MY3 Monitoring Report

Owen Farms Mitigation Site
Transylvania County, NC

Re: MY3 Monitoring Report Comments
Owen Farms Stream and Wetland Mitigation Site
French Broad River Basin; CU# 06010105 – Transylvania County
DMS Project ID No. 100064
Contract No. 7532
SAW-2018-01165

Response to DMS Comments

Figure 8.5: W5 Groundwater Gauge Data (Reference)

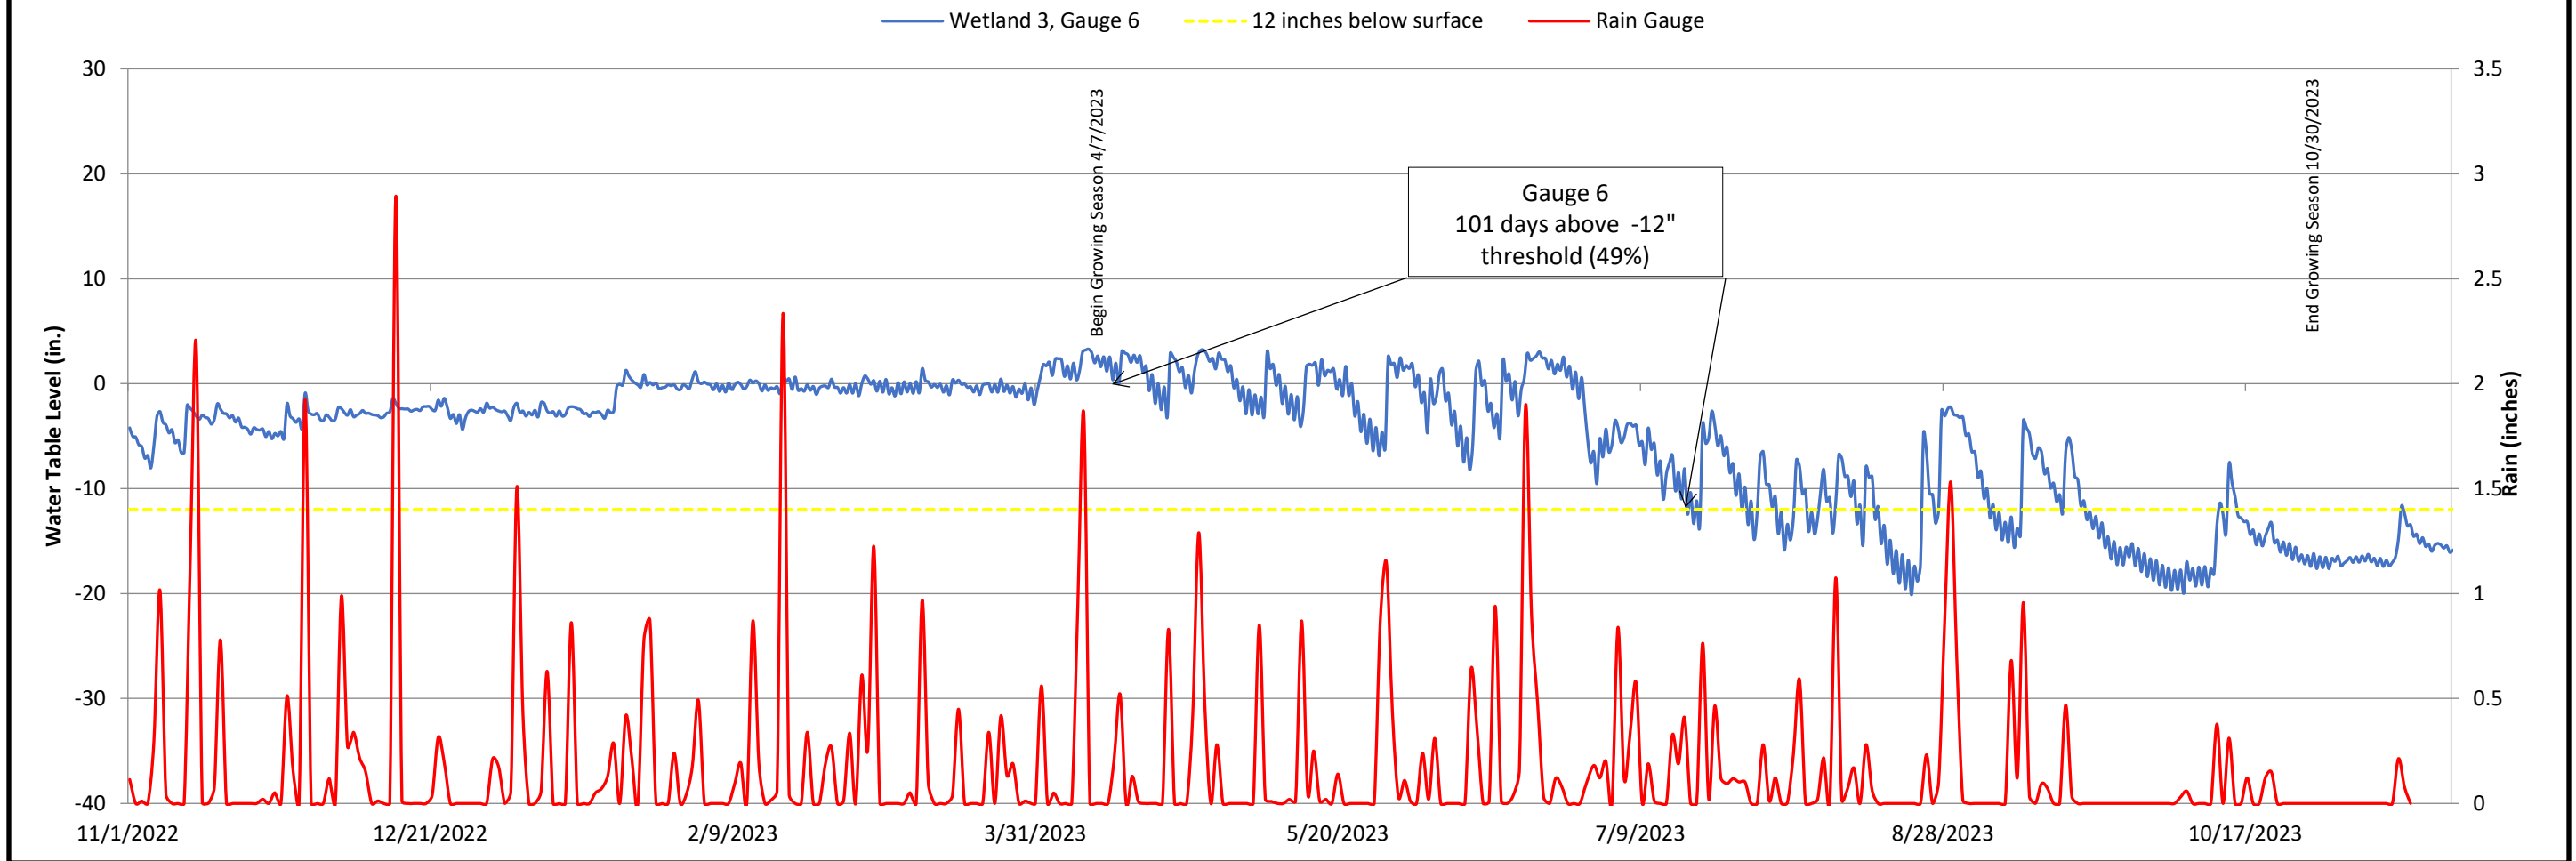
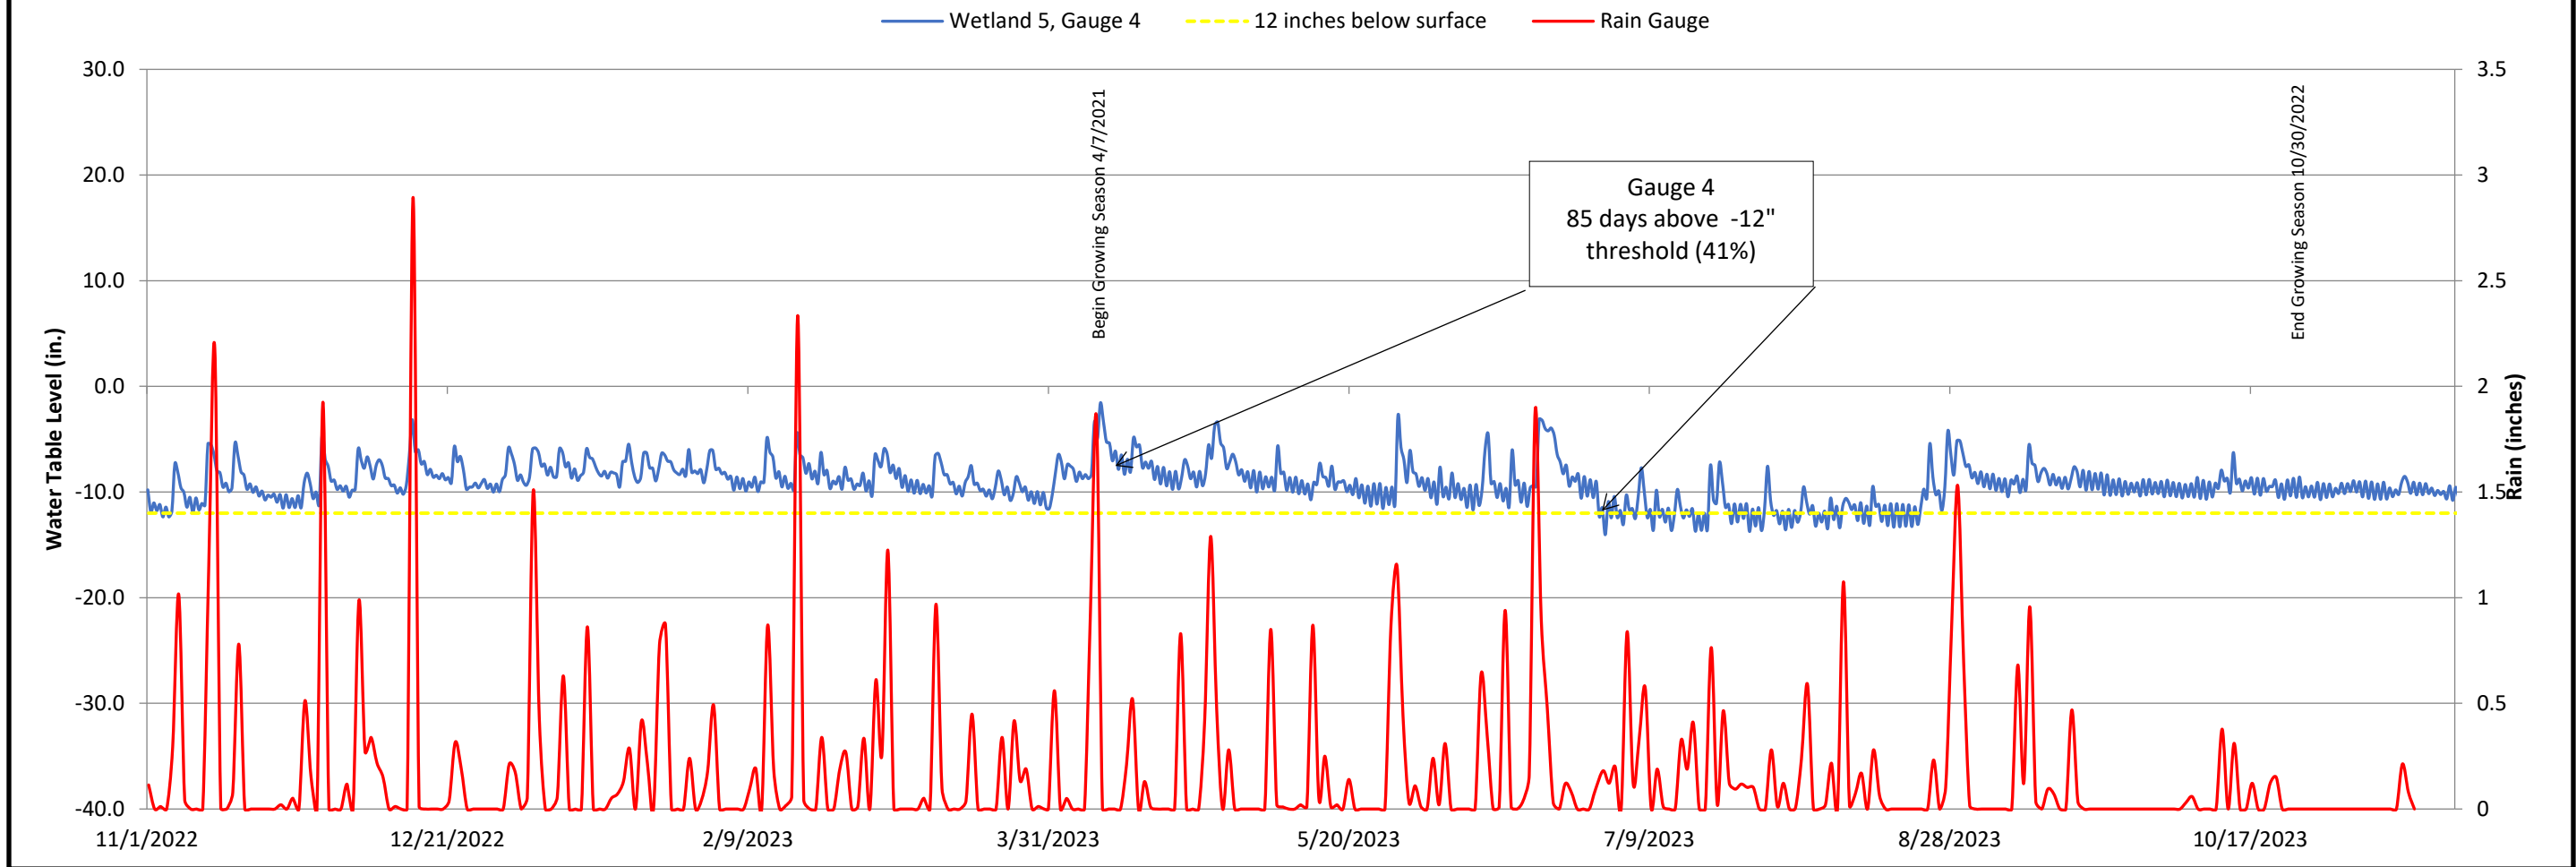
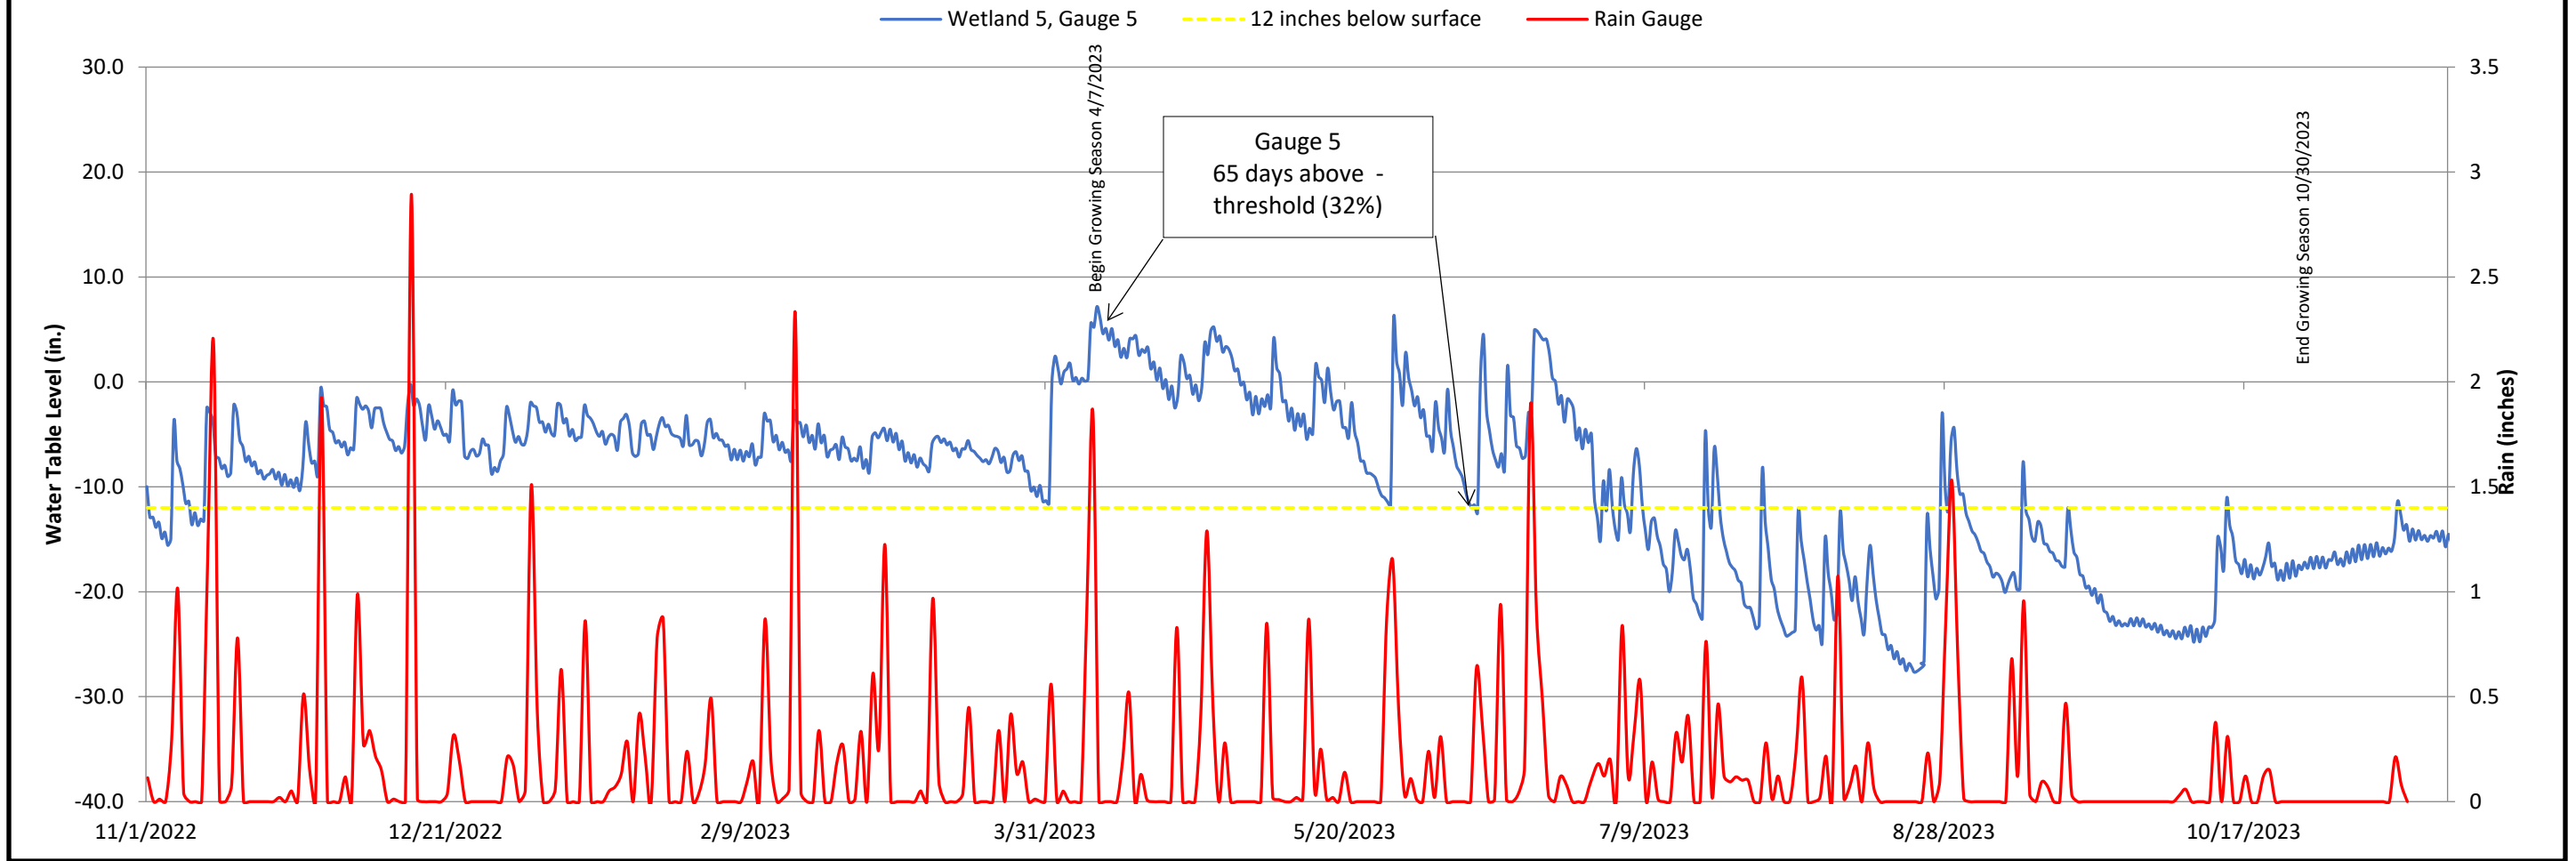
10: Figures 8.1 – 8.6 Groundwater gauge data graphs: Please review and confirm that the data reported is accurate and the graph callouts are correct. As an example, the Gauge 1 (Figure 8.1) callout shows occurrences of the groundwater line well below the “12 inches below surface” line. Please also be consistent with the graph colors utilized. Figure 8.6 has a green “Wetlands 5, Gauge 5 line”. Please review and update the report and graphs accordingly. *Graph data has been reviewed and updated for accuracy and callouts have been updated accordingly.*
